PROJECT Our Town Hall

DRAWING TITLE Repairs and alterations to gables SC29 and NCS26
Cooper Street courtyard

OTH-PUR-TH-RF-DWG-A-4438 02

Elevation SC29

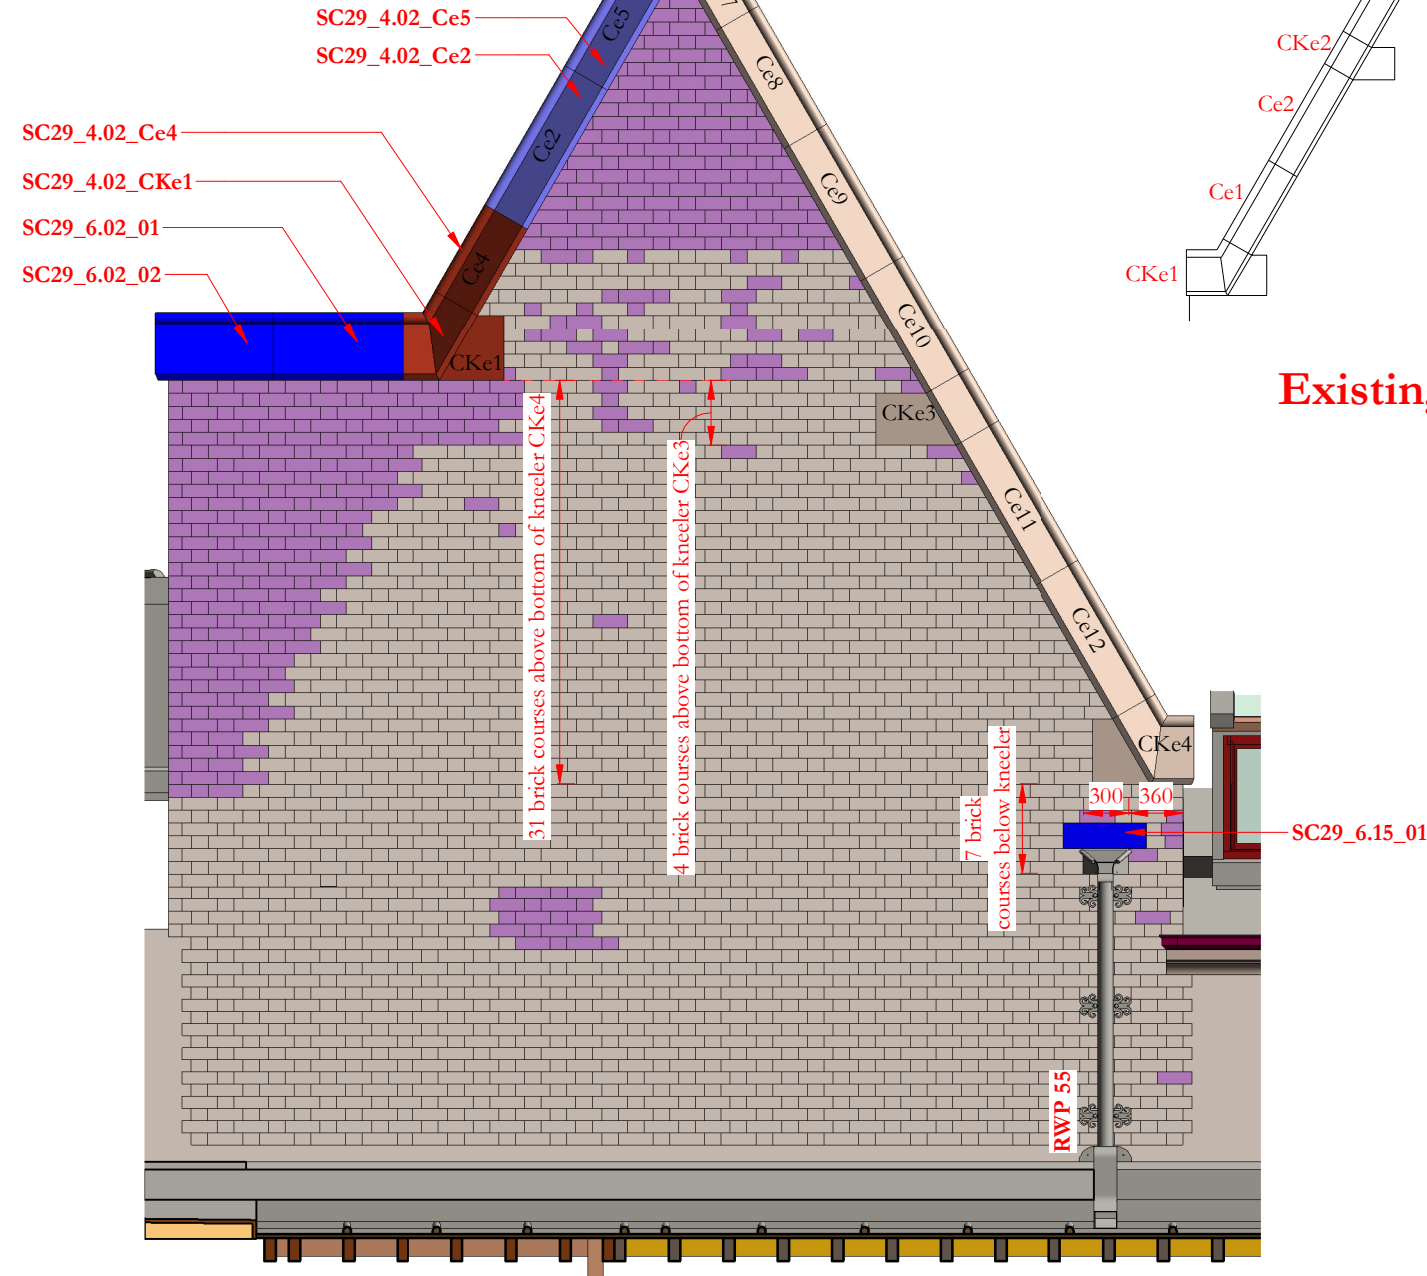
Revision 02: 10 No. additional replacement bricks added (6 No. headers, 4 No. stretchers) 9 on west side of the sexafoil tracery and 1 header above (marked R2 on elevation). Coping Ce13 omitted and substituted with adjusted coping Ce01/03 reclaimed from gable SC29. Notes highlighted to show revisions

Revision 01: Brick coursing heights amended to gable SC29. Setting out of opening for chute outlet for rainwater pipe RWP 55 added

East side of gable to be adusted to accommodate parapet abutment to new lead roof. Existing stone kneeler to be relocated to new position. Brick wall to be built up to new level and new stone copings matching original profile to be fitted to horizontal portion of gable.
Whole gable to wall to be re-pointed
